PRELIMINARY/FINAL DRAINAGE REPORT FOR HIGH PLAINS FILING NO. 1

July 2018

PCD FILE NO's: SP-18-003
SF-18-024

Project: High Plains Filing no. 1
Basin ID: Design Point 1

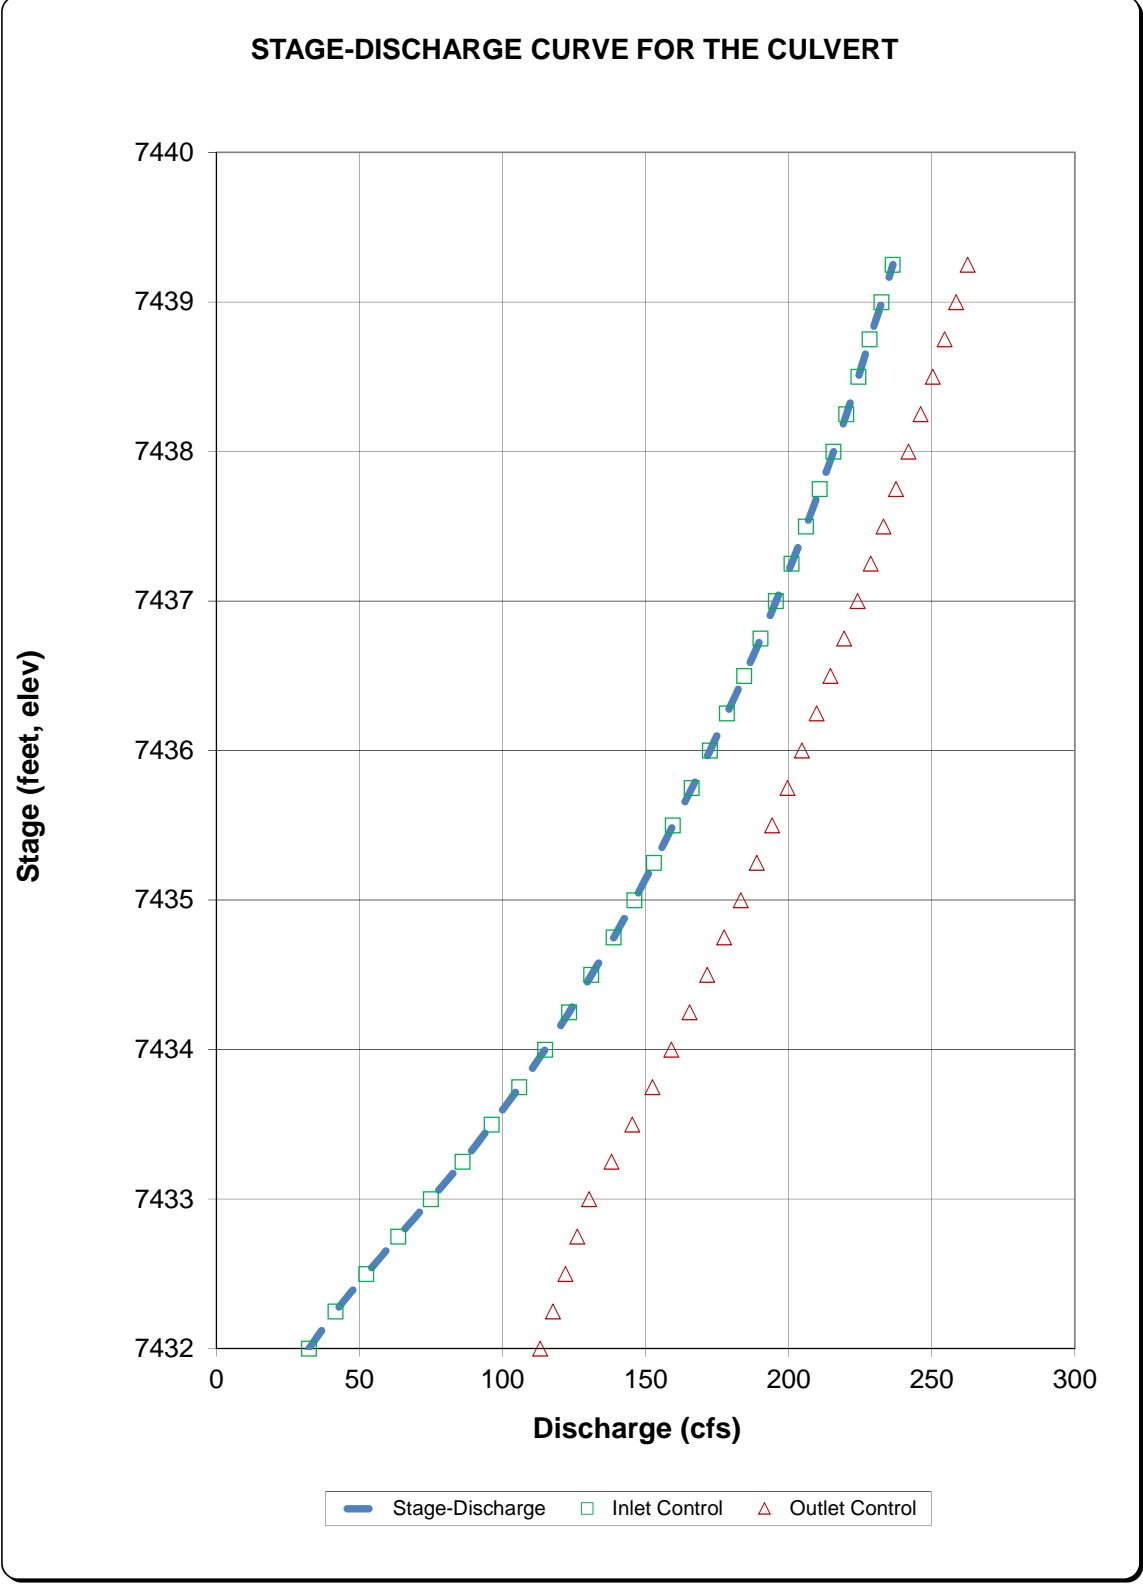
- 1. Resolved.
- 2. Submit the outlet protection calculation
Review 2: Unresolved.
- 3. Provide the Hw/D. Per DCM Hw/D must be less than 1.5.
Review 2: Unresolved.
- 4. Resolved.

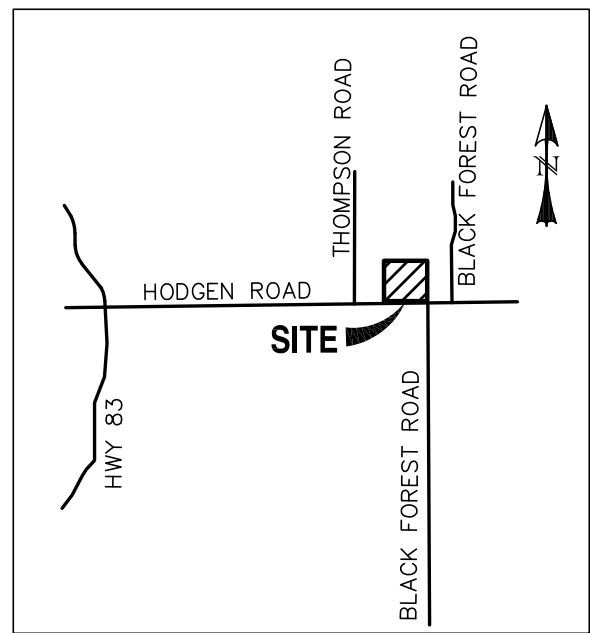
Provide a footnote explaining/showing how the set back was calculated.

* Denotes adjustment made on drawing, 50' further west to be conservative.
